# **Field Modification FM13016F**

## **NX15 to NX400 Transmitters - Replacing the Single-Board Computer**

Issue 1.0 .....30 June 2026

A new generic SBC (Nautel Part # 207-8720-01) must be used as the replacement if the original fails. The new SBC is electrically compatible, but depending on the vintage being replaced, there are physical differences in the connector locations/styles.

Figure SD-3: NX100 Transmitter – Control/Monitor Stage

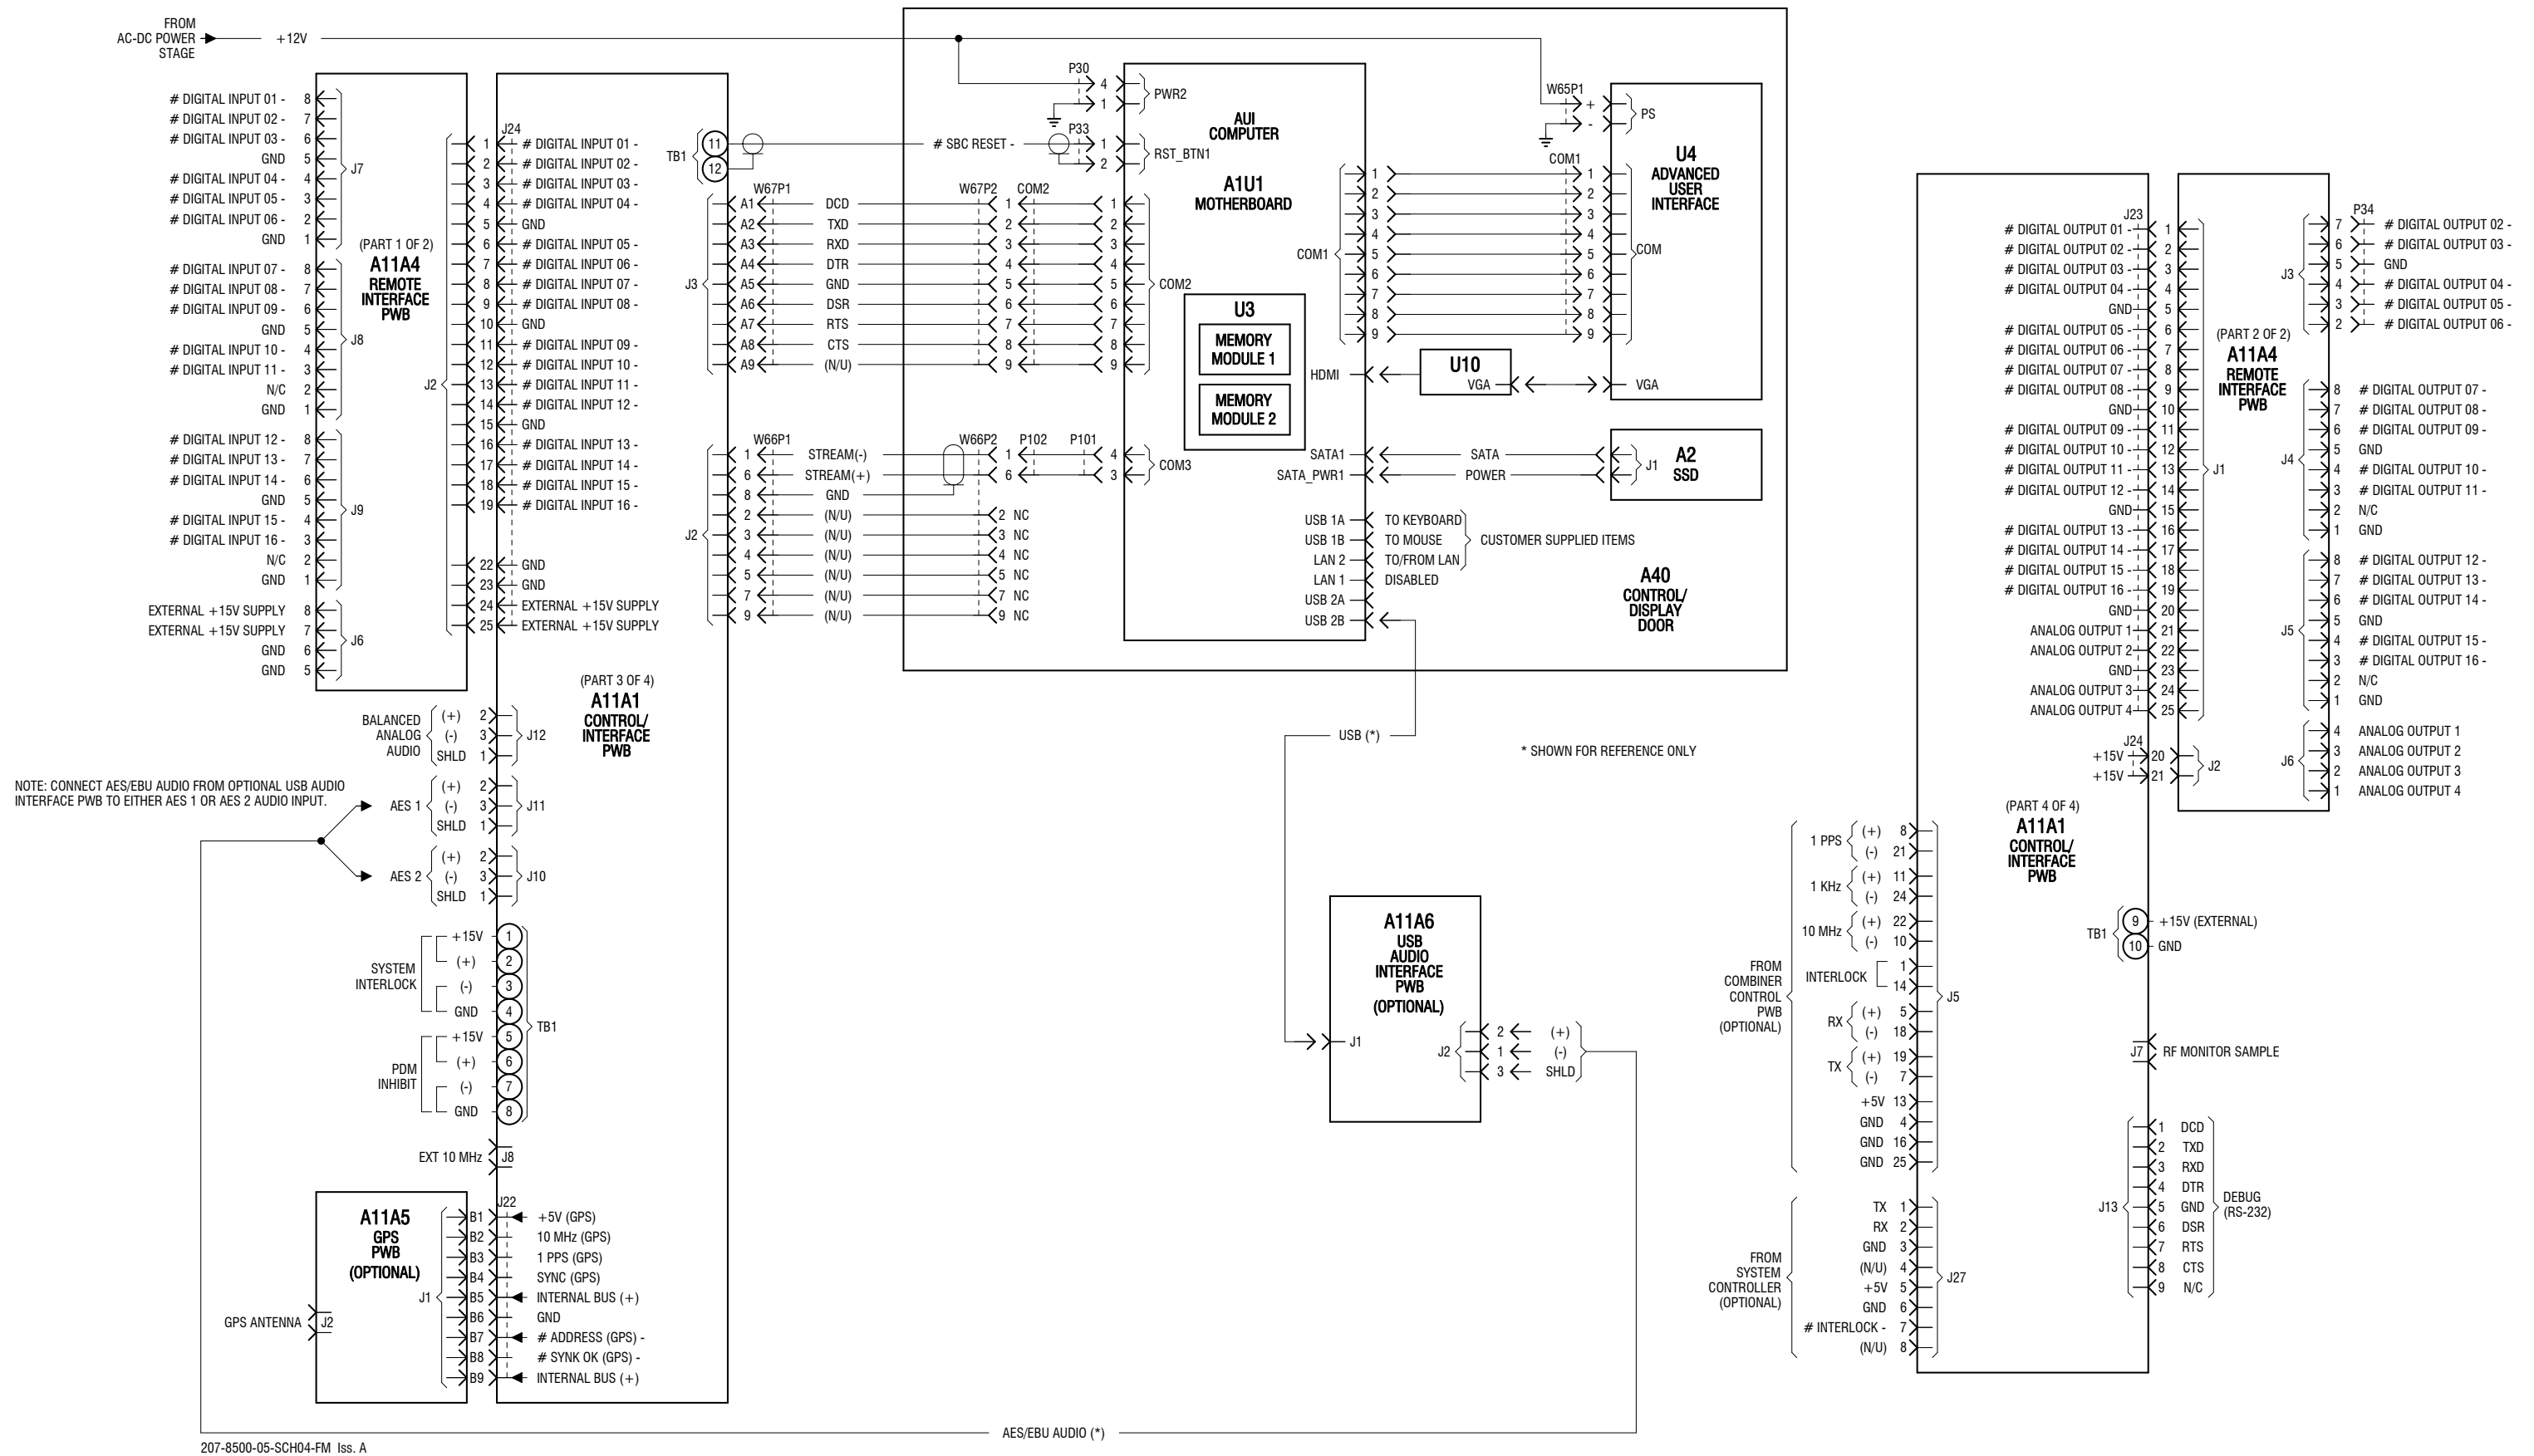
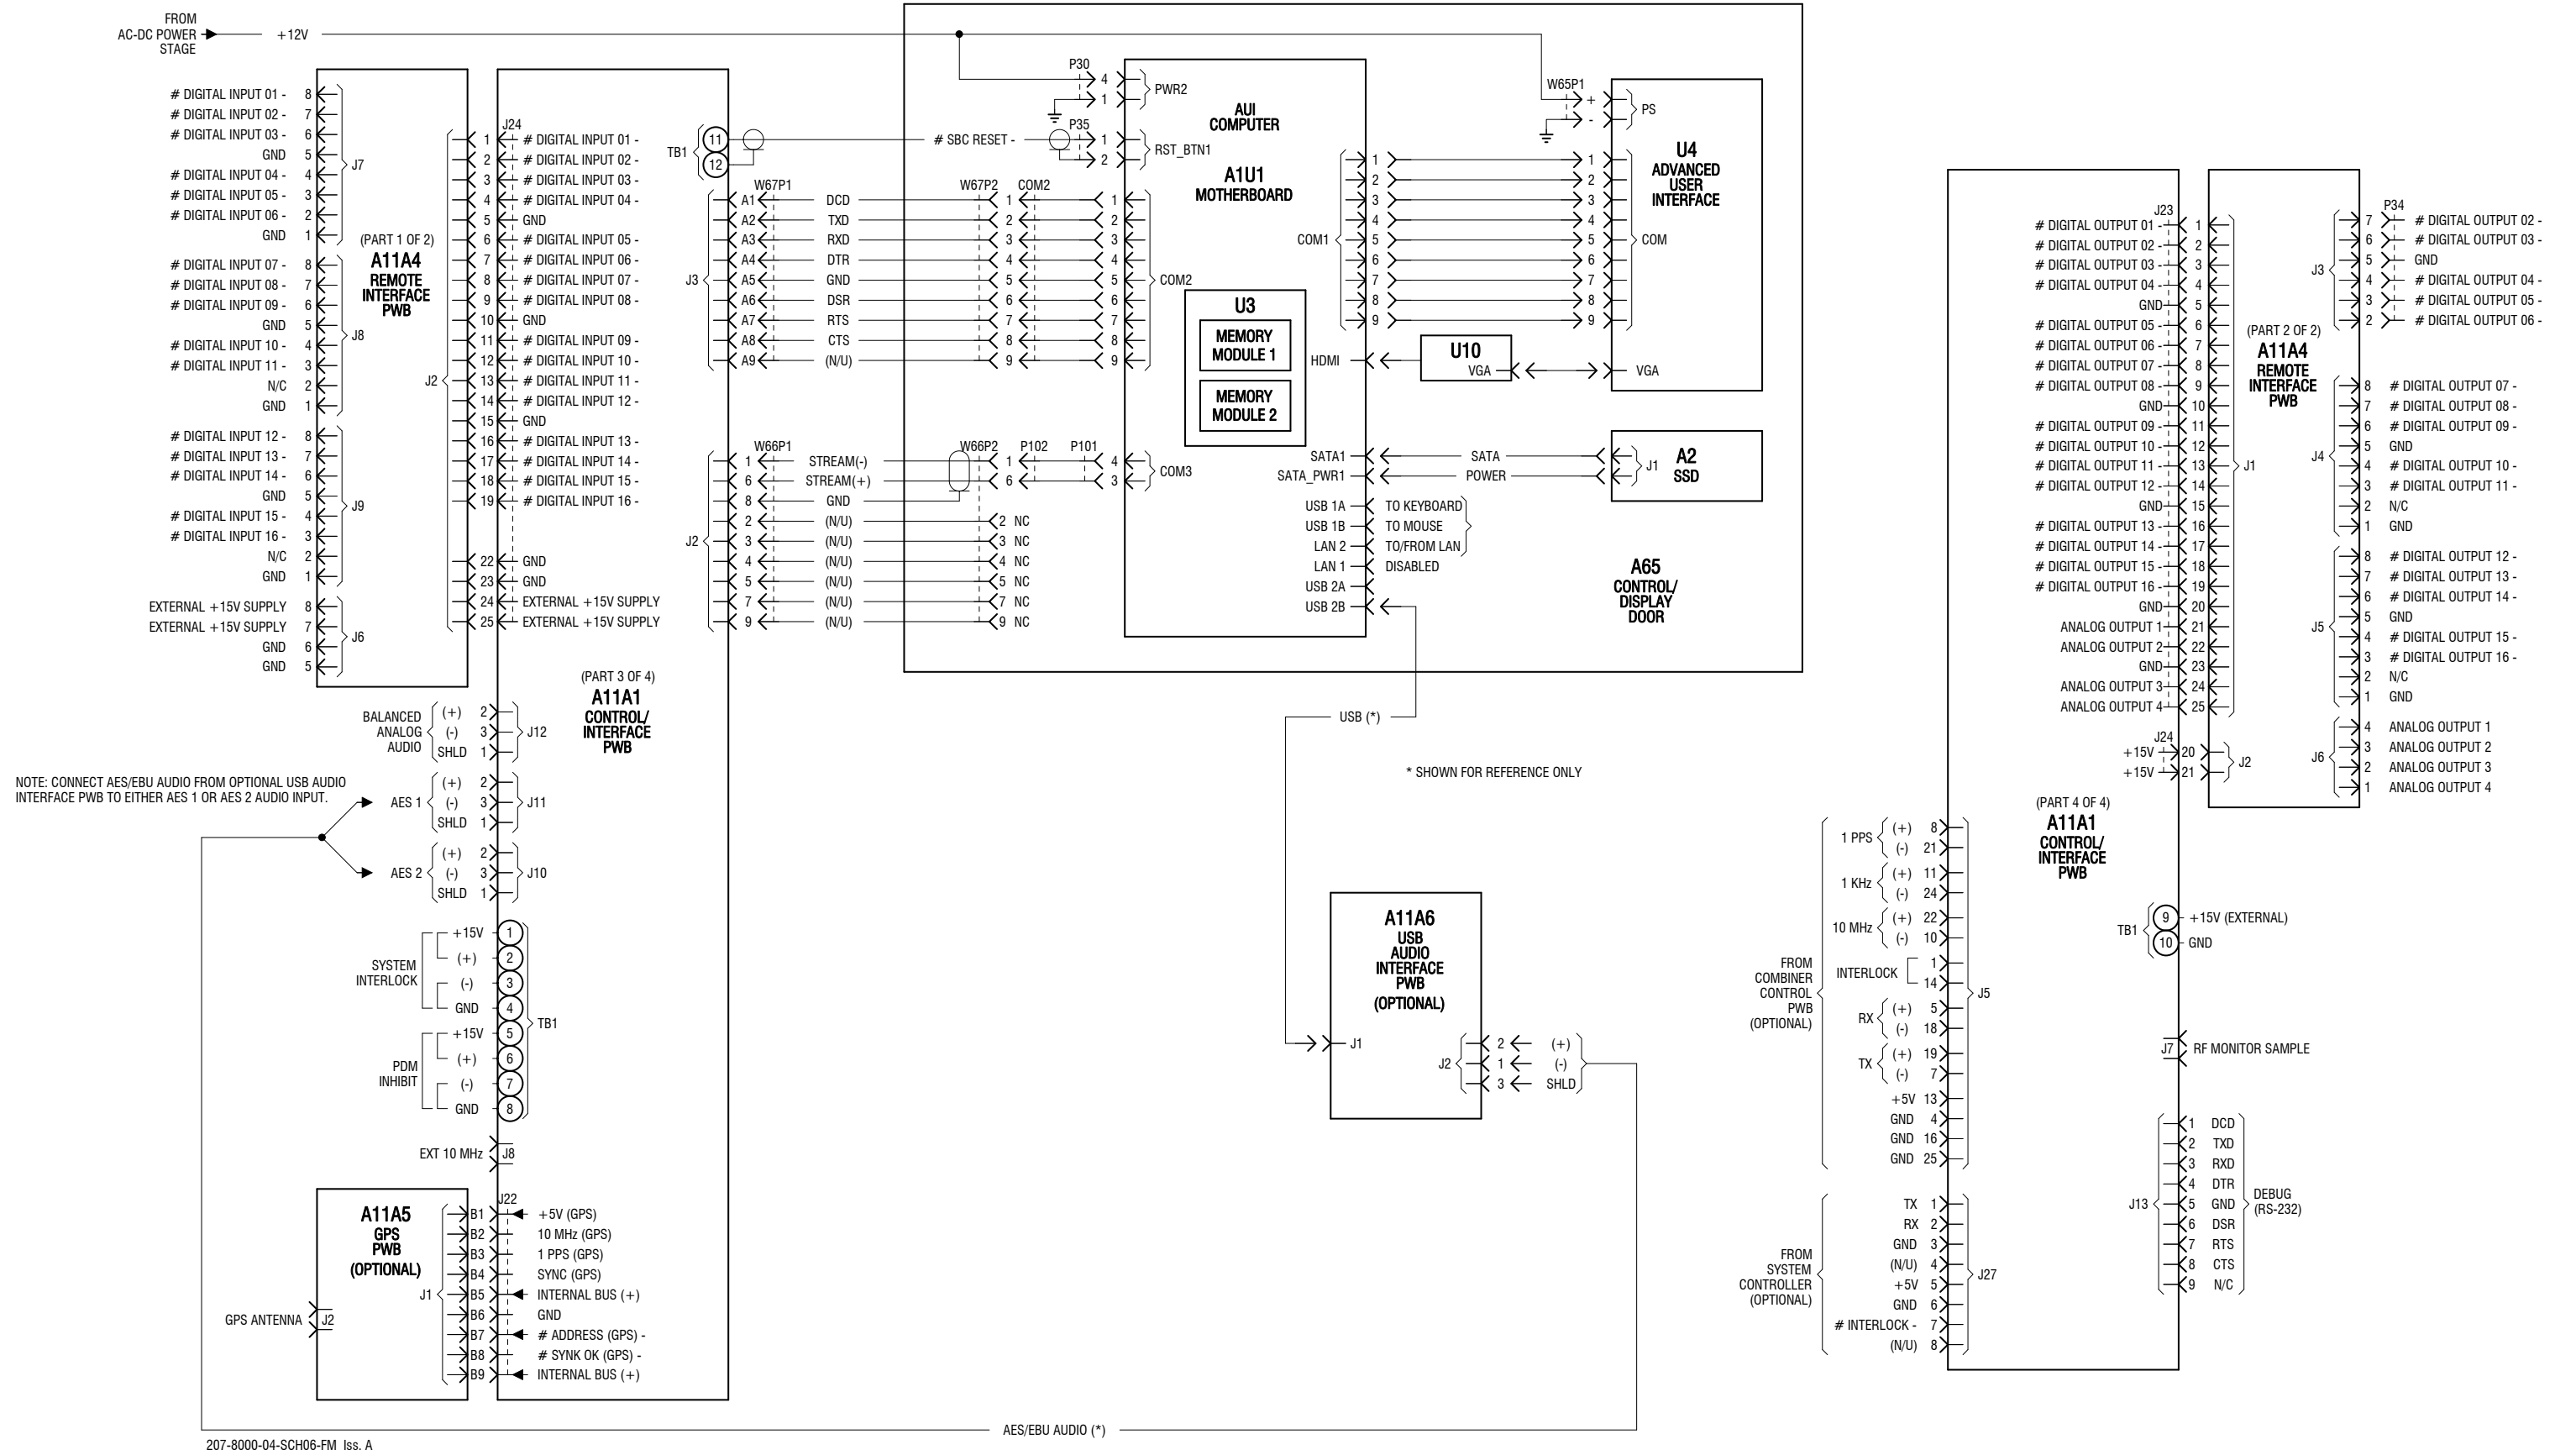
- Insert the applicable replacement Electrical Schematic included in this document and discard the old schematic:

Electrical Schematic SD-3 - Control/Monitor Stage in the NX Troubleshooting Manual with the applicable schematic provided with this document.
